### ADDENDUM: MINIMUM ALLOWABLE CLEARANCES FOR DFS HIGH WALL INDOOR UNITS AND DFS OUTDOOR UNITS

**Document #:** TB-DLS-09192022

**Product Group:** Ductless Indoor and Outdoor Units

Fig 1: Minimum clearances for the high-wall indoor unit

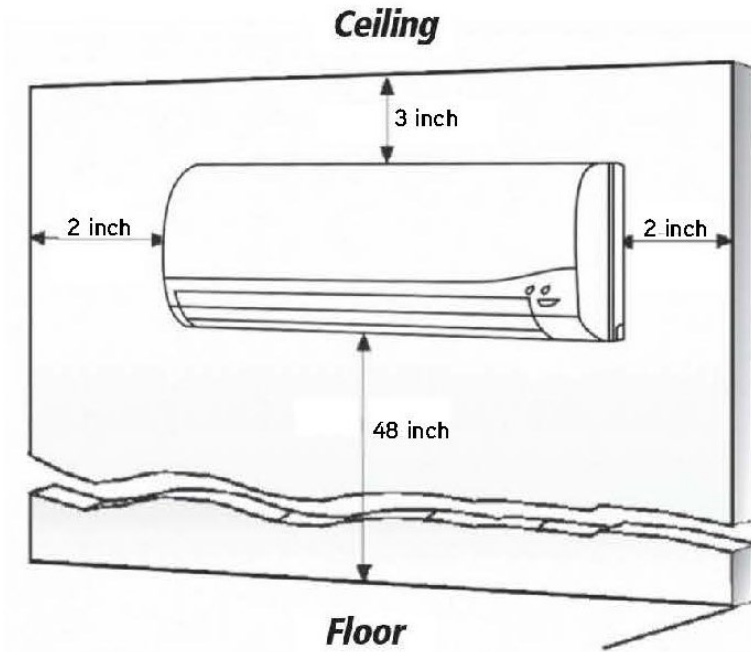
We are amending our current literature which, in the past, has shown “Recommended” Clearances to show “Minimum Allowable Clearances.”

This Addendum will serve notice that GREE will warrant all GREE Branded DFS product installed that adhere to the “Minimal Allowable Clearances” shown in the attachment to this technical bulletin. Manuals and Submittals are in the process of being revised to show these “Minimum Allowable Clearances.” Please use this Technical Bulletin and its attachment for verification to authorities should the need arise.
